Access Compliance Report

Public Rights-of-Way

(Curb Ramps)

Intersection ID: 45519	Main Street: CAPTAIN_ARDREY_RD	Cross Street: COTTON_PRESS_RD	Location:	N
ADA ID: 751DBC634F2F	Ramp Type: PerpDiag	Initial Pass/Fail: Fail	Overall Compliance: No	Severity Score: 8.75
Codes/Mitigation Info/Possible Solution		Field Measurements/Component Compliance

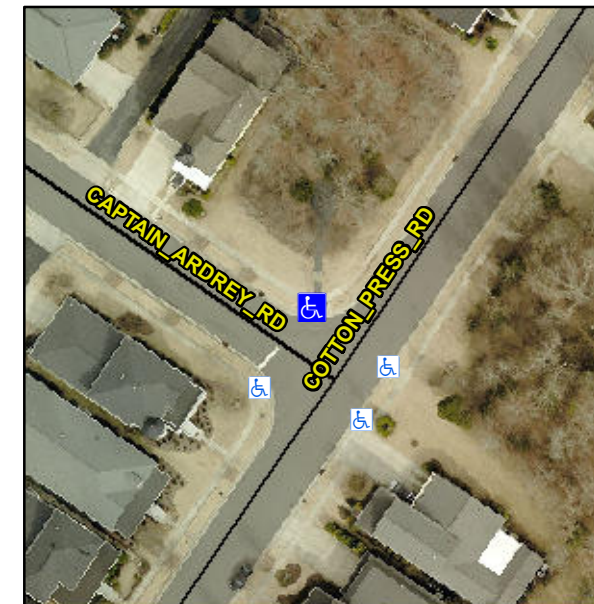
Not Found, R304.5.1

Compliance	Description	Data	Compliance	Description	Data
N/A	Ramp Length (in)	71.0	Yes	Ramp Slope (%)	6.0
No	Ramp Width (in)	37.0	Yes	Ramp XSlope (%)	0.0
N/A	Flare Type LT	N/A	N/A	Flare Type RT	N/A
N/A	Flare Slope LT (%)	N/A	N/A	Flare Slope RT (%)	N/A
N/A	Flare Traversable LT?	N/A	N/A	Flare Traversable RT?	N/A
N/A	Landing Length (in)	N/A	N/A	DWS Provided?	N/A
N/A	Landing Width (in)	N/A	N/A	DWS Contrast?	N/A
N/A	Landing Slope (%)	N/A	N/A	DWS Length (in)	N/A
N/A	Landing X Slope (%)	N/A	N/A	DWS Full Width?	N/A
N/A	Landing Curb? (Y/N)	N/A	N/A	DWS Offset (in)	N/A
N/A	Shared Landing?	N/A			
N/A	Gutter Ponding?	N/A	N/A	Gutter Slope (%)	N/A
N/A	Gutter Lip Ht (in)	N/A	N/A	Gutter X Slope (%)	N/A
N/A	Painted X Walk1?	No	N/A	Painted X Walk2?	No
	X Walk 1 Direction	To SW		X Walk 2 Direction	To SE
N/A	X Walk 1 Width (in)	N/A	N/A	X Walk 2 Width (in)	N/A
	X Walk 1 Slope (%)	1.9		X Walk 2 Slope (%)	1.2
	X Walk 1 X Slope (%)	0.1		X Walk 2 X Slope (%)	2.0

Remove & Replace Curb Ramp With Two New Directional Ramps or Equivalent.
